**Section 5**  
**CALIBRATING EQUIPMENT**  
**L Series**

## SECTION 5. CALIBRATING EQUIPMENT

### → MODEL LM SERIES FIELD CHANGE NO. 1

Figure 1.—Adjustment lever for corrector dial.

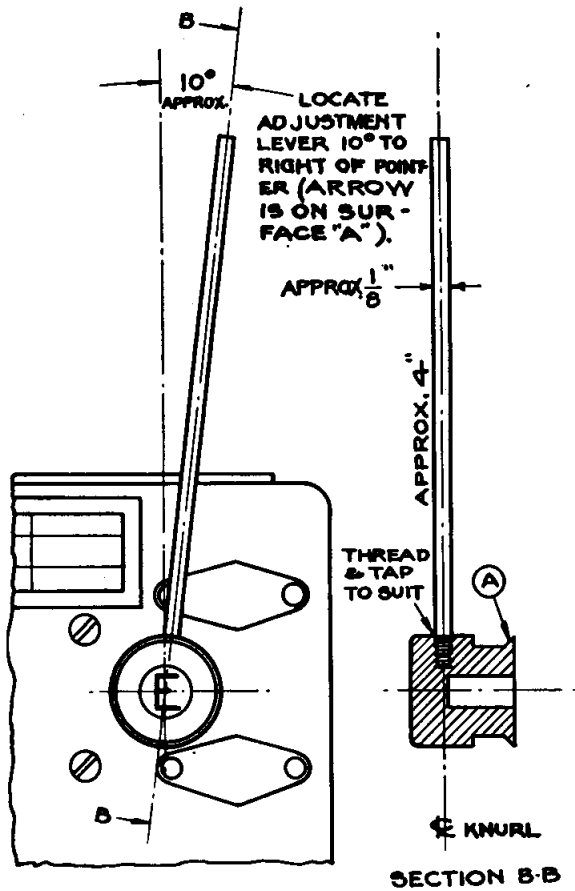
#### ADDITION OF ADJUSTMENT LEVER FOR CORRECTOR DIAL

*Equipment affected.*—All models of LM series.

*Purpose.*—To facilitate the moving of the corrector knob in small increments.

*Action required.*—The corrector knob should be removed from the equipment and drilled and tapped as shown in Figure 1. A brass or steel rod having the approximate dimensions shown in the figure should be threaded at one end. The adjustment lever is offset about 10° in order that the dial be visible when the corrector knob is rotated to its full counter-clockwise position.

*General.*—This change is within the capacity of the ship's force. Record of this change should be made on the ship's "Radio Equipment Log" NAVSHIPS 900,039. Completion of this change should be reported on the NBS-383 failure report form. 6/1/46

FIGURE 1.—Schematic diagram of the LM-18 frequency meter.

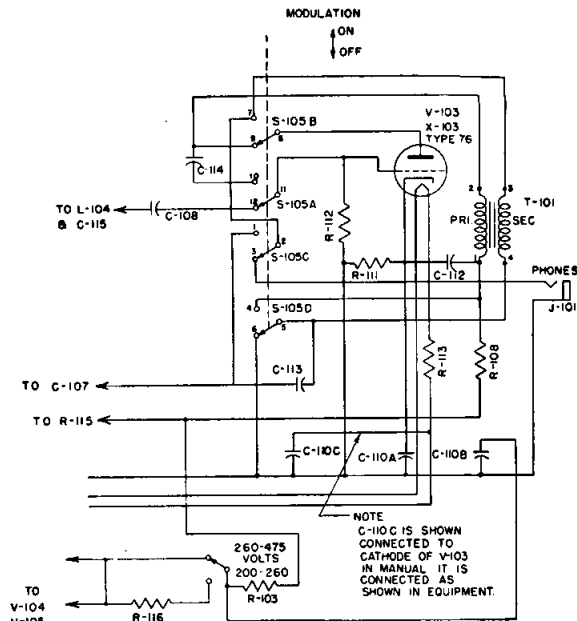
→ DISCREPANCY IN THE LM-18 INSTRUCTION BOOK

The Bureau has been informed of two errors which appear in the LM-18 instruction book NAVSHIPS 900,002. The first one is on page 17, in section V (2d) under the column V-103, which indicates the pin markings and voltages of tube V-103. The pin numbers for the filaments are incorrect, filament 1. should read 6.8AC (5) and filament 2. should read 0.0 (1). The second error appears on the schematic wiring diagram figure 20. C-110C is shown connected in parallel with C-110A while it should be connected as shown on the corrected wiring diagram given here on figure 1. 8/1/46 ←
